Access Compliance Report

Public Rights-of-Way

(Curb Ramps)

Intersection ID: 11920	Main Street: FREEDOM_DR	Cross Street: WOODRUFF_PL	Location: NW
ADA ID: 8038E9C66362	Ramp Type: Perp	Initial Pass/Fail: Fail	Overall Compliance: No
		Severity Score: 10

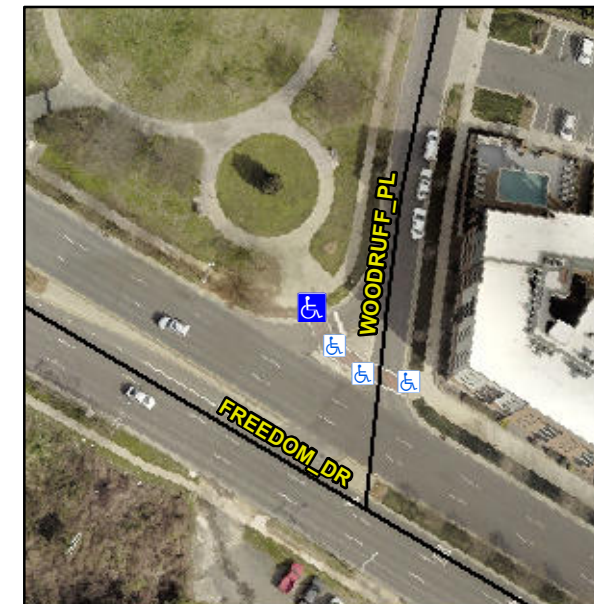
Not Found, R304.5.1, R304.5.3

Compliance	Description	Data	Compliance	Description	Data
N/A	Ramp Length (in)	71.0	Yes	Ramp Slope (%)	5.7
No	Ramp Width (in)	46.0	No	Ramp XSlope (%)	3.5
N/A	Flare Type LT	N/A	N/A	Flare Type RT	N/A
N/A	Flare Slope LT (%)	N/A	N/A	Flare Slope RT (%)	N/A
N/A	Flare Traversable LT?	N/A	N/A	Flare Traversable RT?	N/A
N/A	Landing Length (in)	N/A	N/A	DWS Provided?	N/A
N/A	Landing Width (in)	N/A	N/A	DWS Contrast?	N/A
N/A	Landing Slope (%)	N/A	N/A	DWS Length (in)	N/A
N/A	Landing X Slope (%)	N/A	N/A	DWS Full Width?	N/A
N/A	Landing Curb? (Y/N)	N/A	N/A	DWS Offset (in)	N/A
N/A	Shared Landing?	N/A			
N/A	Gutter Ponding?	N/A	N/A	Gutter Slope (%)	N/A
N/A	Gutter Lip Ht (in)	N/A	N/A	Gutter X Slope (%)	N/A
N/A	Painted X Walk1?	Yes	N/A	Painted X Walk2?	N/A
	X Walk 1 Direction	To SE		X Walk 2 Direction	N/A
N/A	X Walk 1 Width (in)	93.0	N/A	X Walk 2 Width (in)	N/A
	X Walk 1 Slope (%)	1.9		X Walk 2 Slope (%)	N/A
	X Walk 1 X Slope (%)	3.3		X Walk 2 X Slope (%)	N/A

Remove & Replace Entire Ramp.
